Project	IEEE 802.16 Broadband Wireless Access Working Group < http://ieee802.org/16 >
Title	Early transmission of higher layer packets in the idle mode.
Date Submitted	2004-11-04
	<p>Yong Chang, SeoungIl Yoon, Geunhwi Lim, TaeWon Kim</p> <p>Samsung Electronics Co. Ltd.</p> <p>Voice: +82-31-279-3621 Fax: +82-31-279-1234 yongchang@samsung.com</p>
Re:	Re: Sponsor ballot on IEEE P802.16e/D5
Abstract	Early transmission of higher layer packets in the idle mode
Purpose	Adoption of proposed changes into IEEE P802.16e/D5
Notice	This document has been prepared to assist IEEE 802.16. It is offered as a basis for discussion and is not binding on the contributing individual(s) or organization(s). The material in this document is subject to change in form and content after further study. The contributor(s) reserve(s) the right to add, amend or withdraw material contained herein.
Release	The contributor grants a free, irrevocable license to the IEEE to incorporate material contained in this contribution, and any modifications thereof, in the creation of an IEEE Standards publication; to copyright in the IEEE's name any IEEE Standards publication even though it may include portions of this contrib

Figure 1. Call flow of early transmission of higher layer packets in idle mode

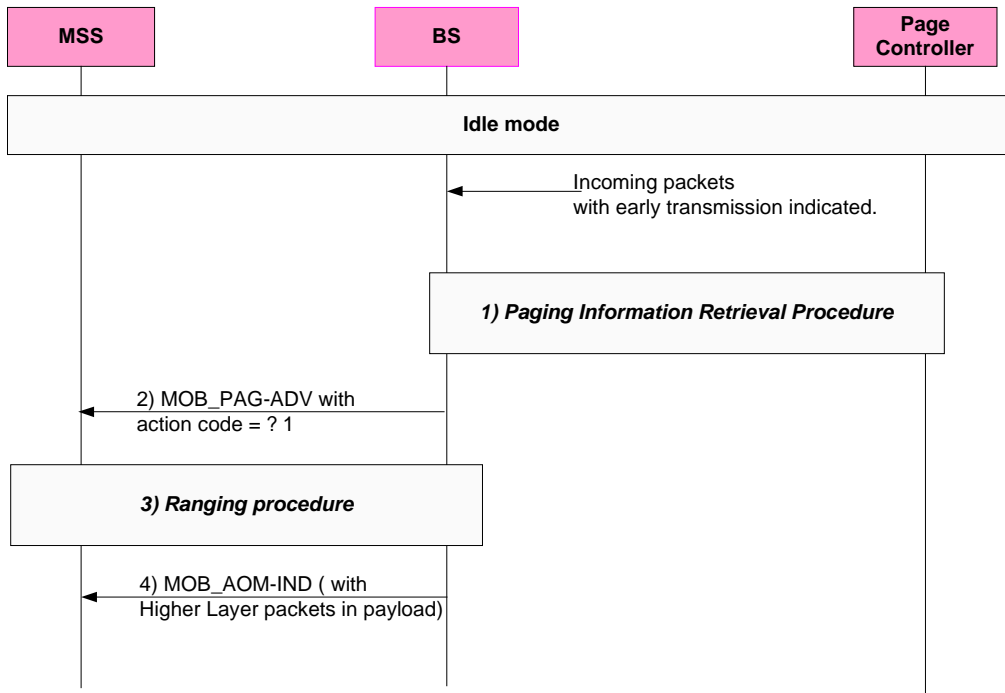
The following figure 1 provides the overview of the early transmission of higher layer packets in the idle mode.

When the MSS has delay sensitive packets in the idle mode, the MSS may initiate an early transmission of higher layer packets by sending MOB_AOM-IND to the BSS just after performing initial ranging procedure.
